**RE: 1100 2nd St. SW – The Yards Parking
G&D Plan - Engineer's Stamp Date 5/01/2019
Hydrology File: K14D105**

SHEET TITLE
GRADING AND DRAINAGE PLAN

SHEET NO:
C-103

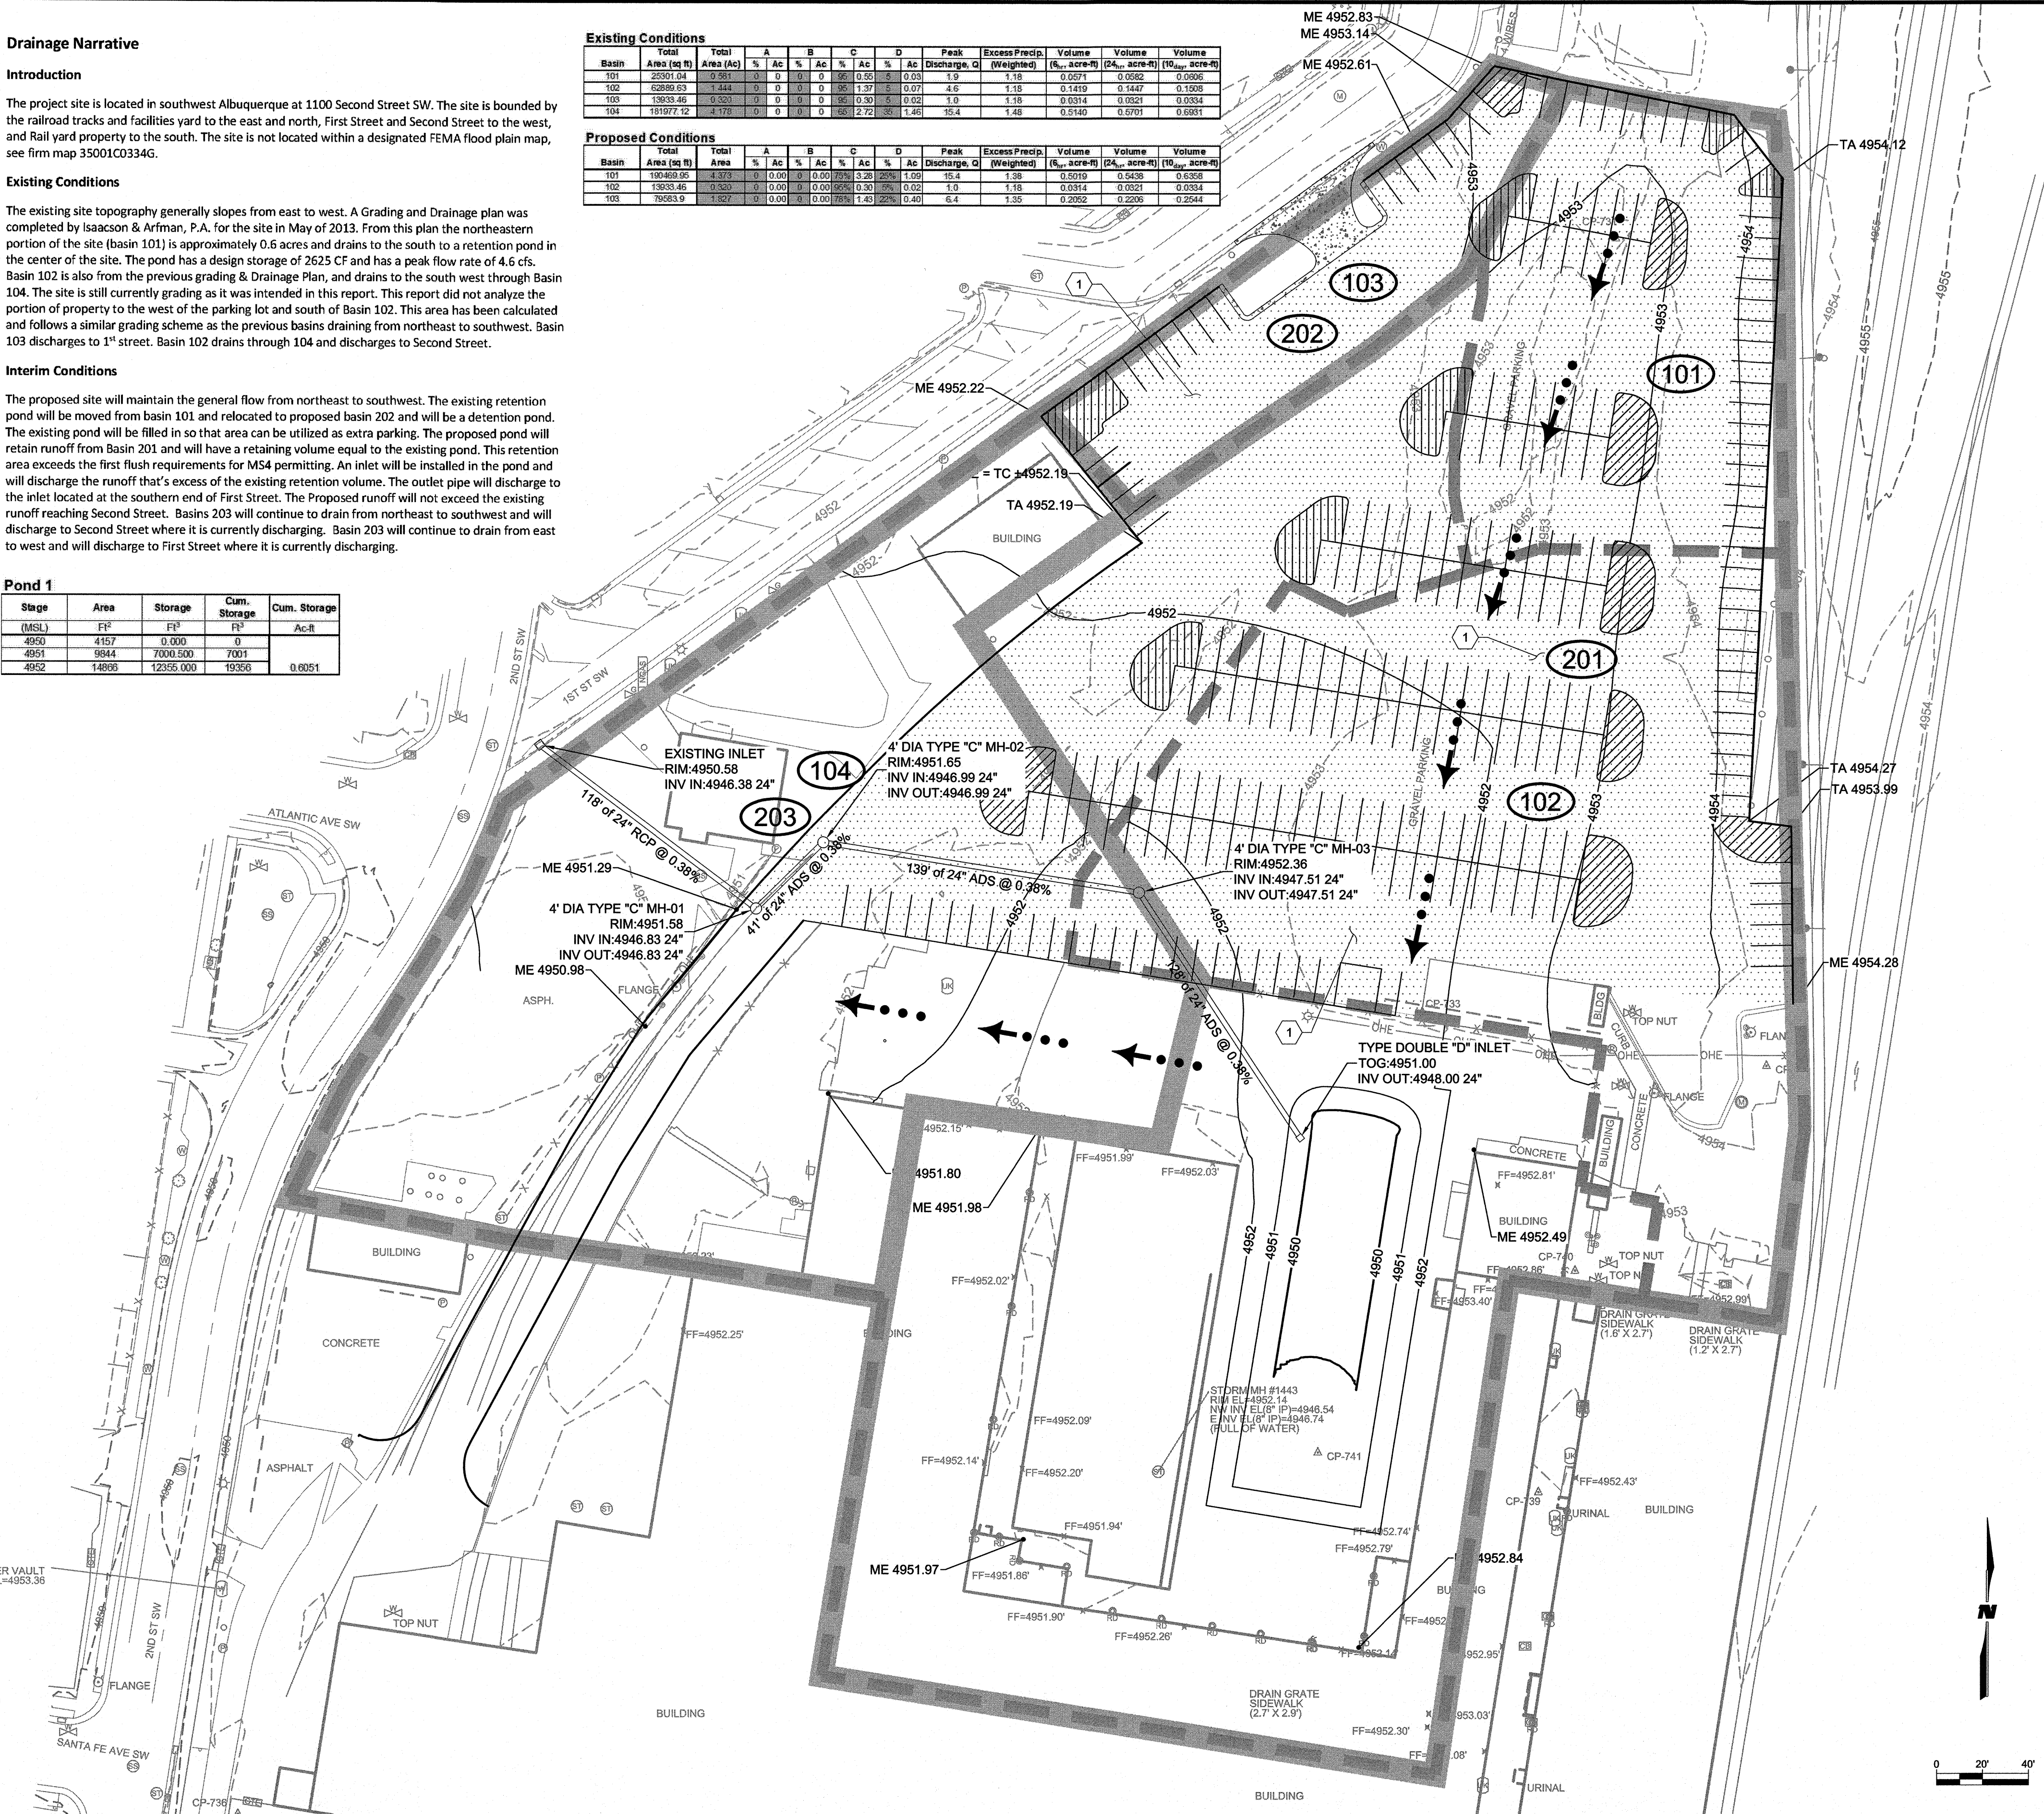
1. Separate approval is required from Paul Olson at City Environmental Health prior to construction.
2. A Drainage Covenant is required to insure maintenance of the pond prior to sale of the property.
3. An Engineer's Certification is required prior to Hydrology release for Certificate of Occupancy.
